**3600@Villard**  
3600 W. Villard Avenue  
Milwaukee, WI 53209

Submittal for Minor Modification to the Detailed Plan Development  
Original File Number: 160917  
Submitted: December 21, 2016

New File Number: 181488  
Submitted: February 11, 2019  
Updated: February 13, 2019

## Owner's Statement of Intent for a Minor Modification

C200

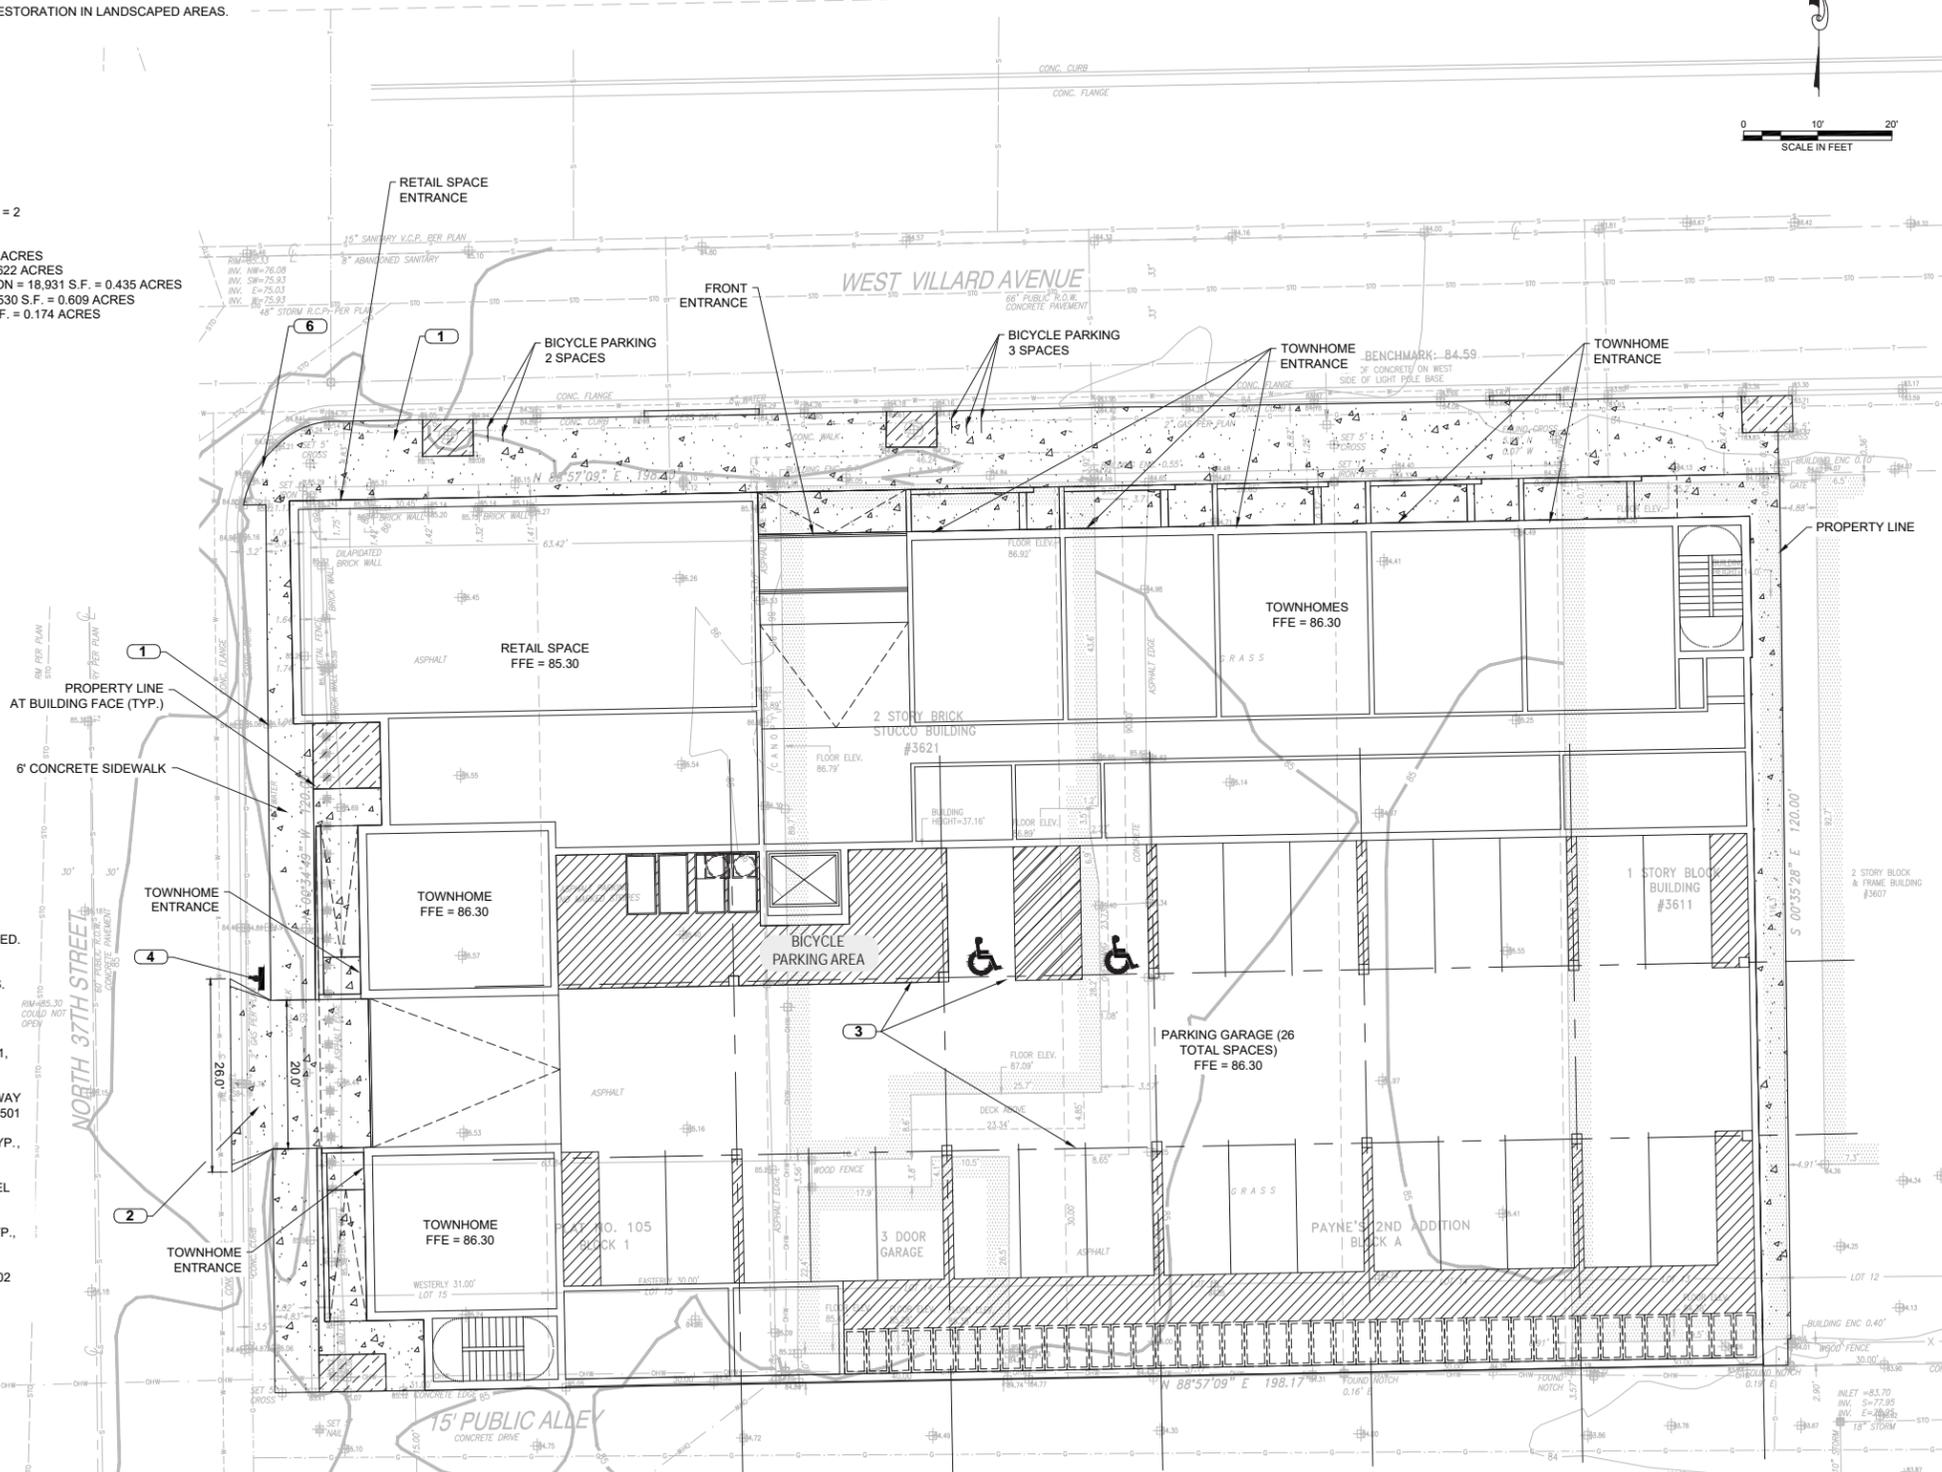
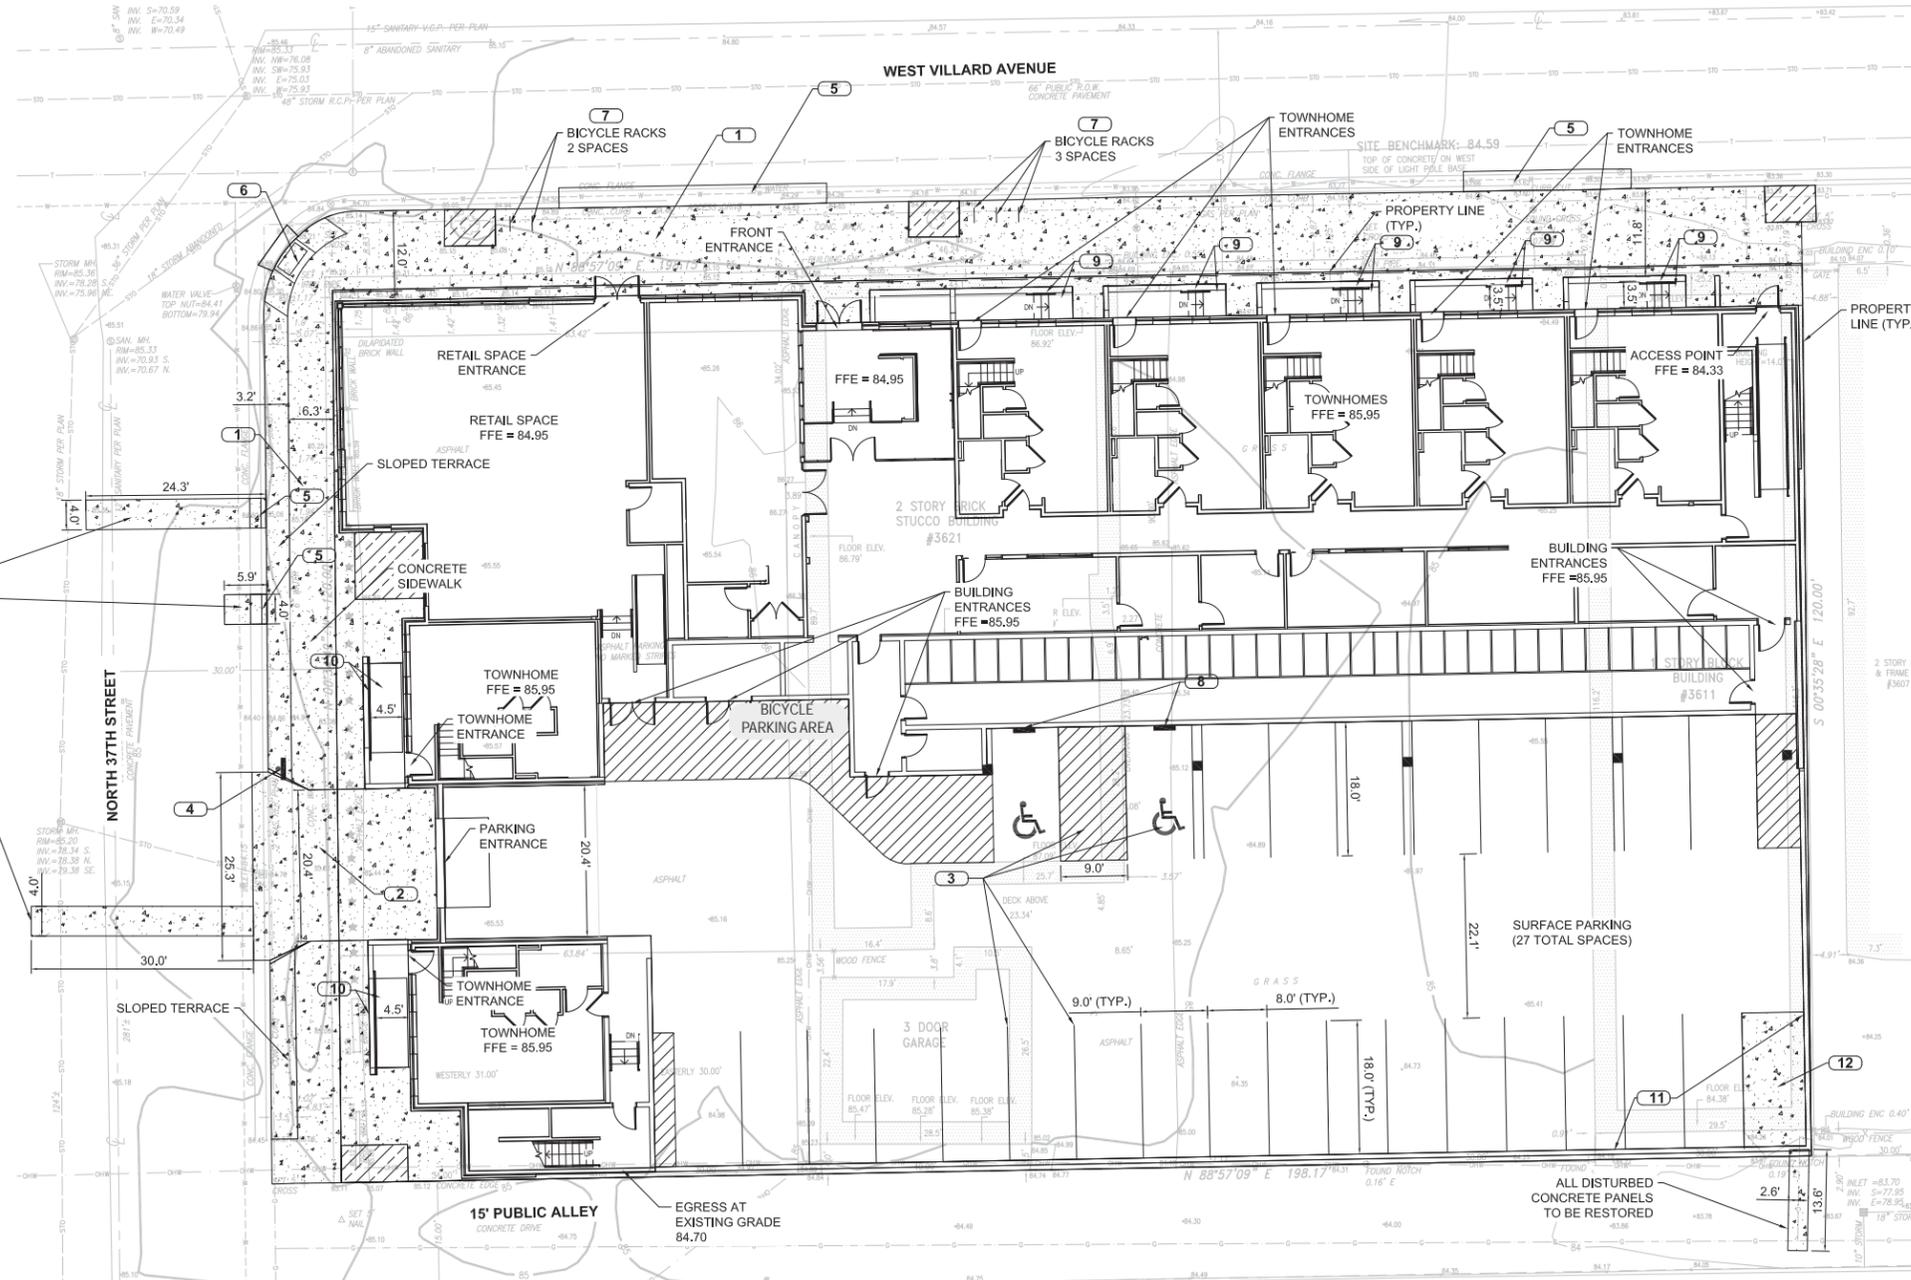
A Detailed Plan Development (DPD) was approved on January 18, 2017 (#160597). It approved a four-story, 43-unit, mixed-use building with enclosed parking at the back of the property. As the design was further refined, the applicant is requesting that the previous enclosed parking become a surface parking lot. The painted concrete masonry unit wall at the south and east facades enclosing the parking will be removed from the project. The amenity deck, once on the roof of the enclosed parking, will be removed from the project. The surface parking lot will be enclosed with a maximum 2'-0" high painted concrete masonry unit retaining wall topped with a 6'-0" decorative metal fence. The previously approved DPD included up to 26 parking spaces. The transformer will be located outside on a concrete pad at the south east corner of the site. The modified surface parking will include up to 27 spaces. The parking will be illuminated with wall mounted lighting on the south and east facades of the building. Light poles may be added along the fence line as needed. The street facades will remain unchanged and parking access will remain from the overhead door at the west side of the building. The trash collection will remain enclosed within the building. The bicycle parking will be moved to enclosed within the building.

The building contains an enclosed surface parking lot (previously enclosed heated parking) accessed from N. 37th Street and contains up to 27 parking stalls (previously 26 parking stalls) for use by the residents.

REVISIONS	DATE	DESCRIPTION
0	12/02/16	CITY SUBMITTAL
1	02/11/19	MINOR MODIFICATION TO DPD

TOTAL PARKING SPACES = 27  
ADA ACCESSIBLE PARKING SPACES = 2
